## **1360 (1330) Ogilvie**

Design Brief  
Site Plan Control  
July 10, 2024

Prepared for Better Living Housing Co-op

Figure 13: Extract of Site Plan submitted for Initial Pre-application Consultation

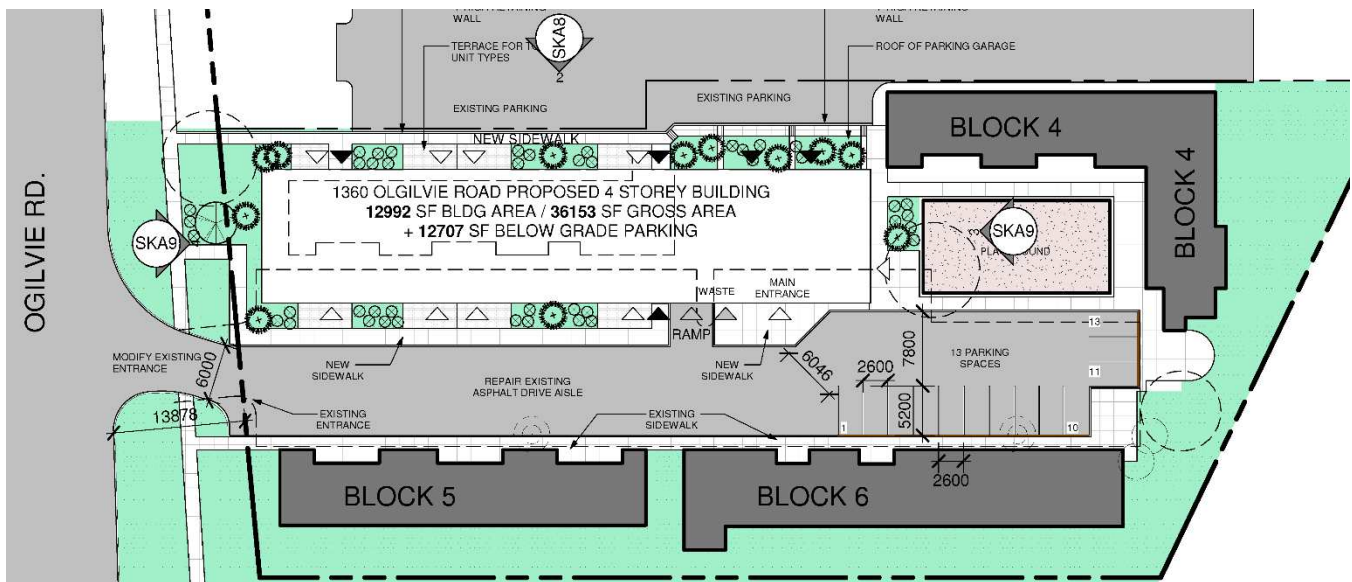
Figure 13 shows the Site Plan originally submitted to the City. Staff's preliminary comments on the design related primarily to the orientation of the building towards Ogilvie, and to site landscaping, particularly retention and planting of canopy trees.

As the design evolved (Figure 14), the treatment of the drive aisle and central amenity space was refined, with less space devoted to parking. In response to staff comments, at-grade entrances for two ground-floor units were added facing Ogilvie Road.

Figure 14: Extract of Site Plan submitted for second Pre-application Consultation

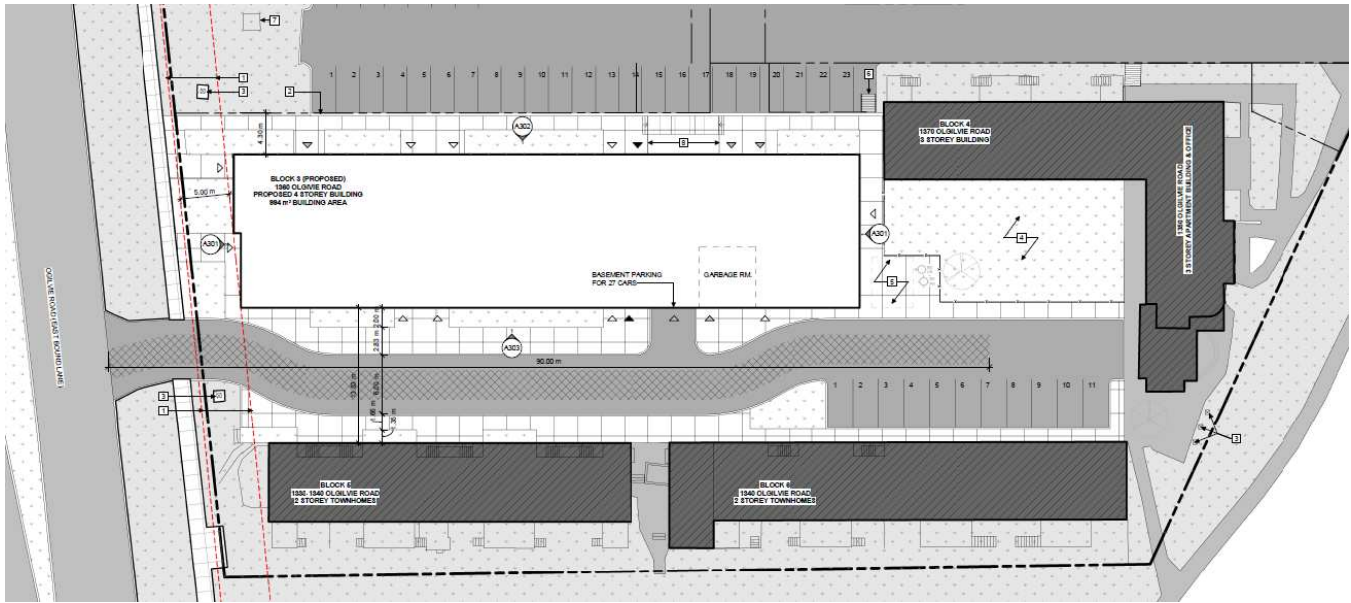
Upon review of the updated concept, Staff reconsidered the direction to provide active entrances and pathways between the front-facing ground floor units and Ogilvie Road. Instead, staff requested that these be removed to provide additional room for soft landscaping and tree planting.

Additional discussion revolved around pedestrian access and barrier-free design. Staff flagged concerns with the width of the pedestrian pathways, particularly at the pinch points created at the ends of Block 3. Widening of these pathways was not desirable, because it would have required a reduction in the size of the affordable units, and/or more expensive building construction techniques.

Figure 15: Extract from Current Site Plan

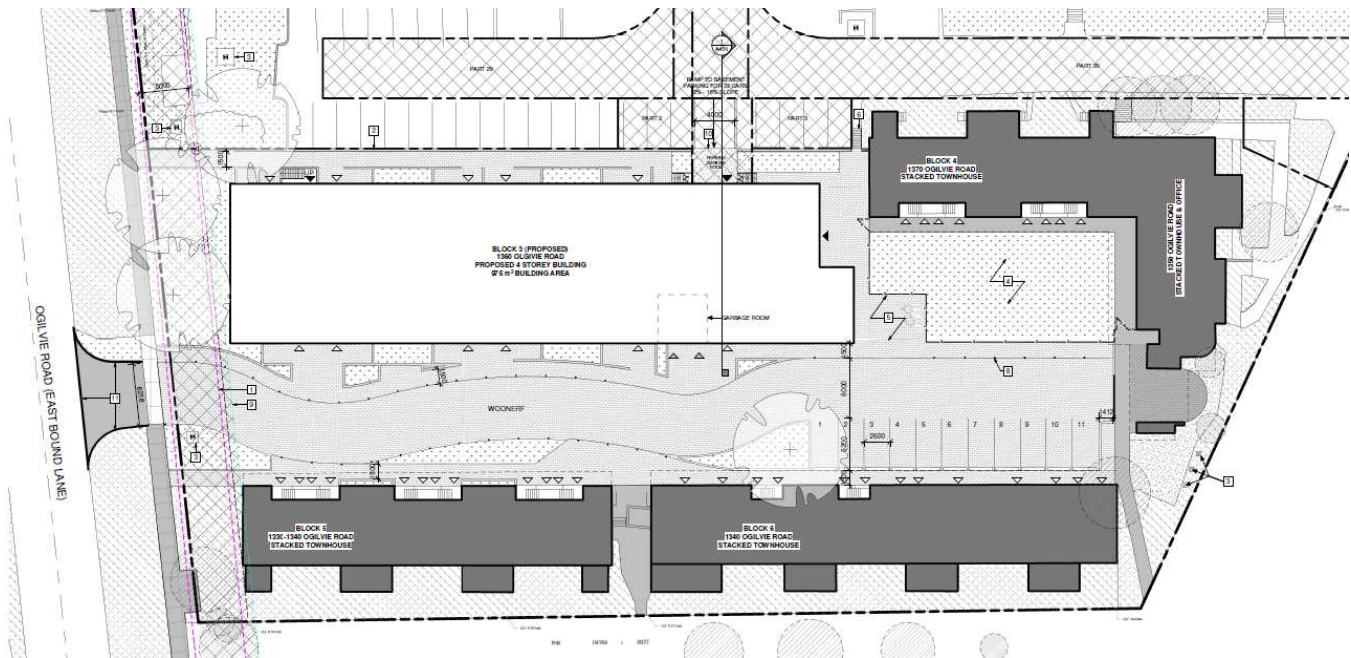
18	The 2.83m walkway west of the proposed building may be narrowed to 2m so that areas of soft landscaping can be increased. Alternatively, the driveway may be shifted toward to the proposed building so that the walkway and the landscaping area in front of Block 5 may be increased.	The driveway has been redesigned as a woonerf, allowing the extent of hard surface to be narrowed and the amount of landscaped area to be increased.

In response to site constraints, a woonerf design for the driveway is now proposed. Woonerven are “living streets”, where pedestrians, cyclists and vehicles share the same space. Design interventions, which often include visual narrowing/limiting of sight distance, lack of continuous curbs, different paving styles, and soft and hard landscaping are used to cue drivers to travel at walking speed and share the space equally with pedestrians. The intent is that these spaces serve as public space for social interaction, while still accommodating some local vehicular access.

- / The curb radii at the entrance have been narrowed to slow vehicles entering the site;
- / The drive aisle introduces curves indicated by landscaped islands and bollards to slow drivers;
- / No curbs (except for pinned curbs for the parking spots) – instead, bollards indicate the delineation between the shared space and the pedestrian only space directly in front of building entrances.
